Consistency Assessment Approval Form – Change to Tunnel Alignment between Waterloo and Sydenham

Planning approval reference details (Application/Document No. (including modifications)): SSI-15_7400 Sydney Metro City & Southwest – Chatswood to Sydenham

Figure 1: Approved and proposed tunnel alignment

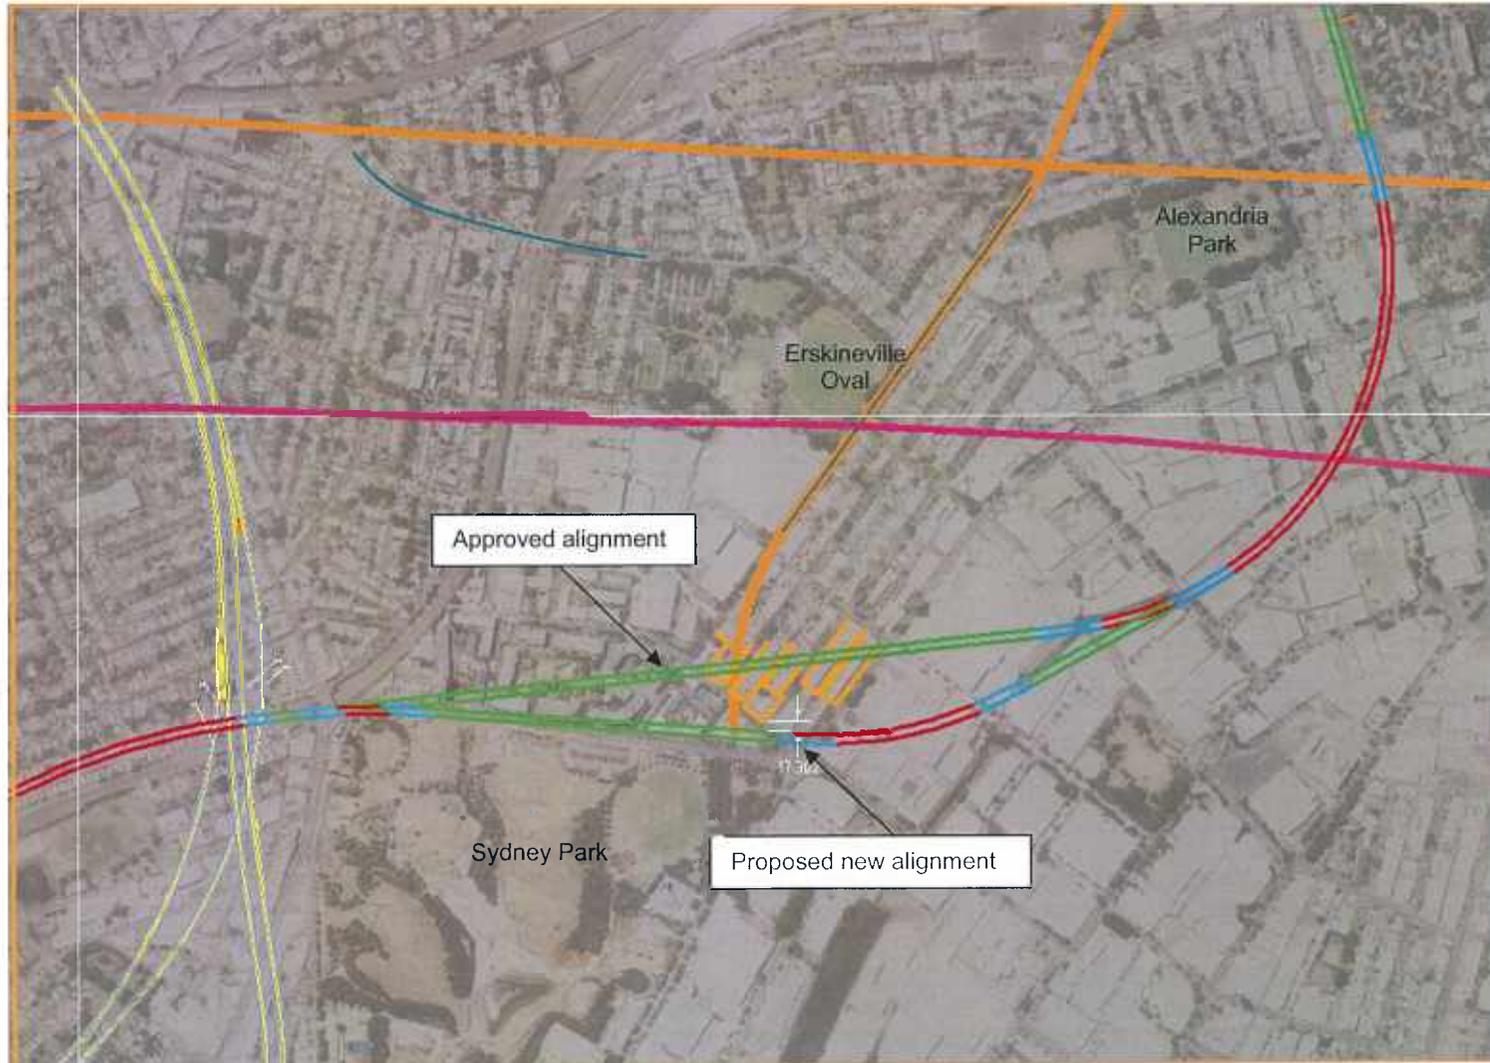
Sydney Metro proposes to alter the horizontal tunnel alignment of the new metro rail line between Waterloo and Sydenham (near Lawrence Street, Alexandria) to avoid the substratum of land that has been vested to the Metropolitan Local Aboriginal Land Council (Metropolitan LALC). Further justification of the proposed change is detailed in the relevant section below.

The approved and proposed tunnel alignments through this area are shown in Figure 1. The proposed change to tunnel alignment adds about 40 metres of additional length to the overall tunnel between Chatswood and Sydenham.

The additional 40 metres of tunnel length would add about 2 days of tunnel construction and 3,000m³ of excavated materials.
